MGAC Markups
DA Draft 1/06/2022

DUKE OF KENT RESIDENTIAL FLAT BUILDING DEVELOPMENT
21, 23 & 25 NORTH PARADE, WAGGA WAGGA LOT: 56, 57, 58 DP: 21115

OVERALL GROUND FLOOR & SITE PLAN - NORTH PARADE

SK-128

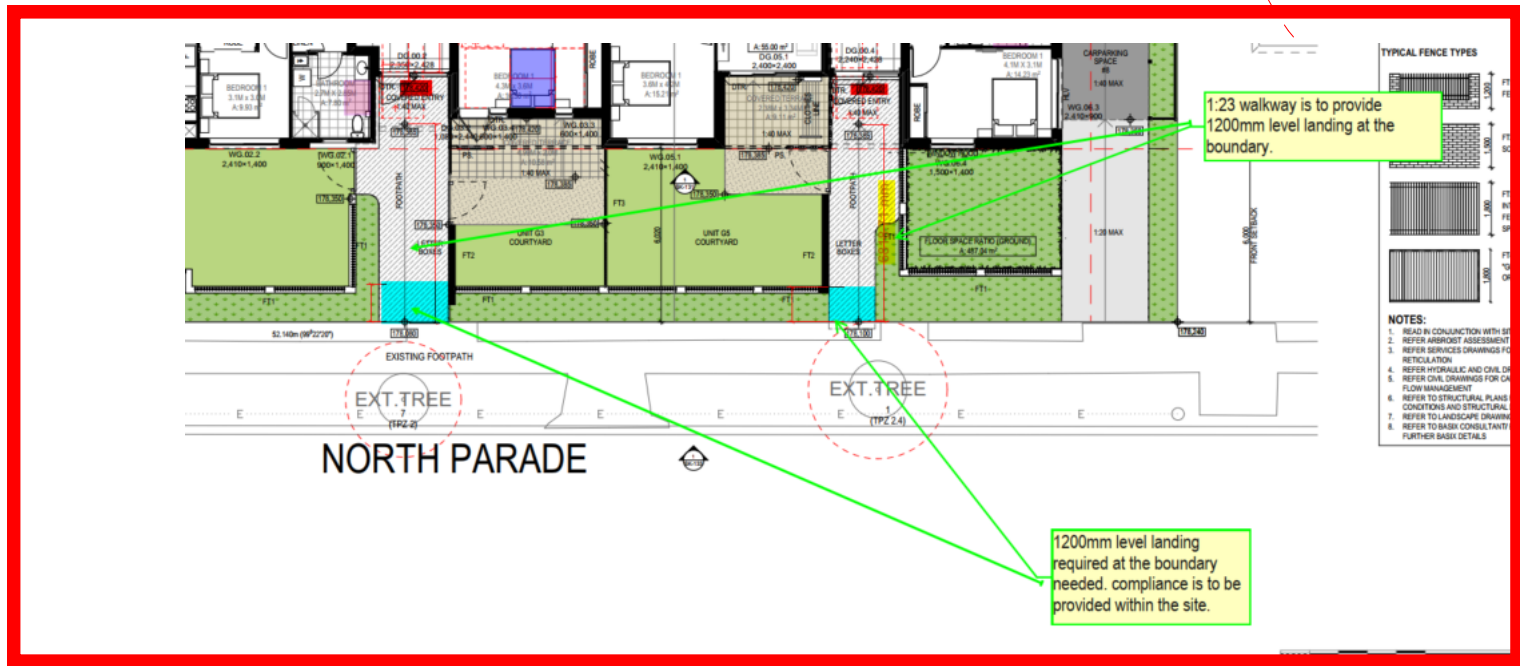
395mm Latch side needed side approach

2000mm x 1800mm clear circulation needed(lack of line of sight)Solid wall or wall is to be lower

1:21 is to provide 1200mm min level landing. Compliance is to be achieved with in the boundary. Refer to previous reviewsaa

510mm (ext) mLatch side needed side approach

Letterbox to be provided on level/on-grade surface 1540mm x 2070mm clear circulation needed

Can be resolved at later design stages. Enough space to be adjusted for compliance

Can be resolved at later design stages. Enough space to be adjusted for compliance

Can be resolved at later design stages. Enough space to be adjusted for compliance
